From: Aisha Teesdale
To: Brian Senior
Subject: Re: Entrance Window
Date: 06 June 2019 09:07:44
Attachments: 2019-06-06.jpg

AMENDED

Dear Mr Senior,
The drawing number on application NYM2019/0365/fdet is revision C, hence the confusion!
With your instruction I will copy the front elevation of Rev D over onto this file too – you had obviously already had the same thought!

FRONT ELEV

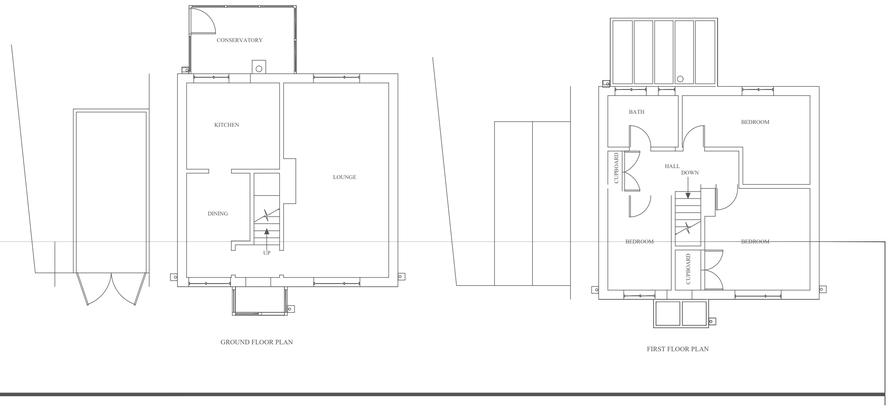
Dear Mr Senior,
Thanks for your sketch, it isn't so much the size of the window that is the issue, it just needs to be broken up with an off centre vertical division to break up the massing of the glazed element but maintain the horizontal emphasis.

I hope that makes sense. If you wish to re-use the existing dining room window or a new one of a similar size then this would also be acceptable.
I will require the drawing to be amended and resubmitted.

Hi Aisha,
Yes, Please go ahead with that. I attach the image required. It is only a screen shot so if resolution is poor please feel free to take it from the plan I'll send you in a moment. (The detail is identical.)
Kind regards,
Brian

Hi Aisha,
I'm really sorry that I'm not quite the hot-shot Revit drawing looks like it does this already… the frame of the opener provides an off centre vertical…see detail attached.
